SR 9 Intersection Improvement

**SR 9 at CR 600 N/Hauser Drive, 4.49 Miles North of SR 46
Bartholomew County**

Des. No. 0100774

SUBJECT: Scope Comments
SR 9 at CR 600N
Bartholomew County
Des No 0100774

ALTERNATE B	INDIANA DEPARTMENT OF TRANSPORTATION	HORIZONTAL SCALE 1" = 100' VERTICAL SCALE 1" = 20' SURVEY BOOK CONTRACT
DESIGNED: GRW CHECKED: DPF	DRAWN: NLC CHECKED: GRW	BRIDGE FILE DESIGNATION 0100774 SHEETS A-12 of PROJECT
S.R. 9 - PLAN & PROFILE		STA. 21+00 TO STA. 35+85 "A"

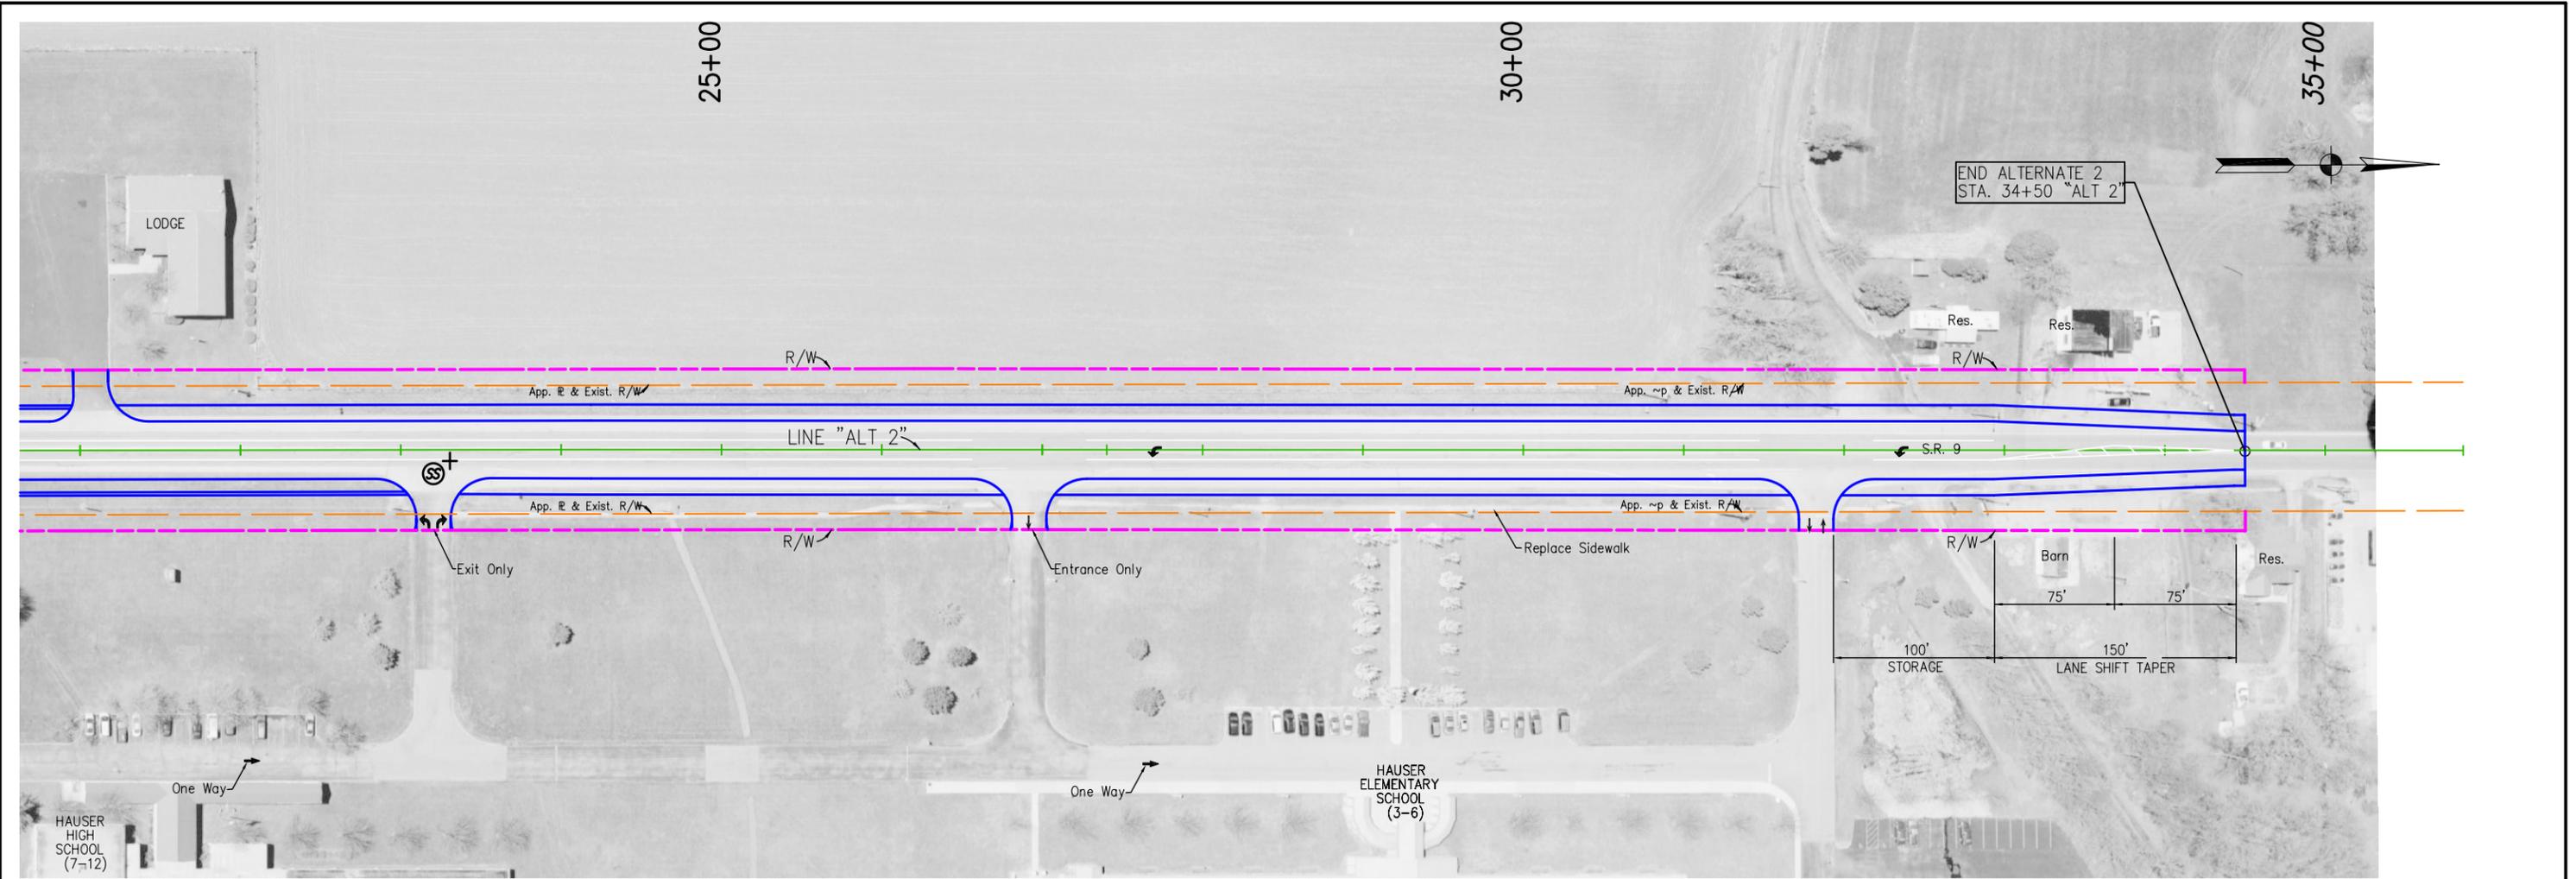
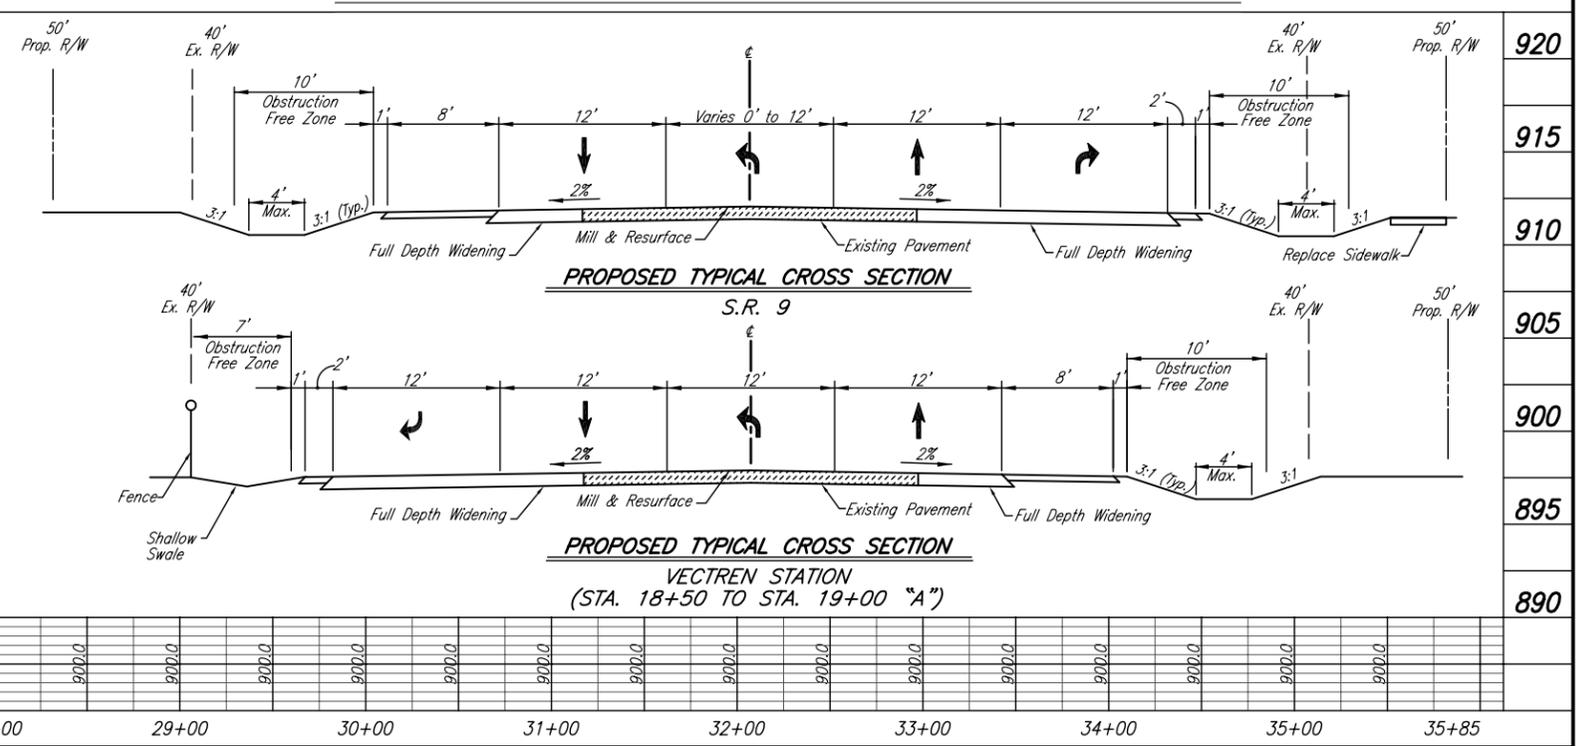
1. On Page 8, the project recommendation states that there is no apparent crash history at the school drives, but the crash data on page 5 states there was a Fatal at that location. How does this affect the preferred alternate.
2. The air-photo shows existing sidewalks by the school, do we need to incorporate pedestrian crossings and sidewalks in the design?
3. On Sheet B-4, why does the AADT drop from the year 2019 to 2029? Does this affect the design?
4. Can we get approval from the county engineer to set a speed limit or design speed for the west leg of CR 600N? If we don't get info, we must design for 55 mph.
5. We will need to upgrade both legs of CR 600N to design standards. Plan accordingly for the environmental.
6. Do we need turn lanes on the CR 600N approaches?
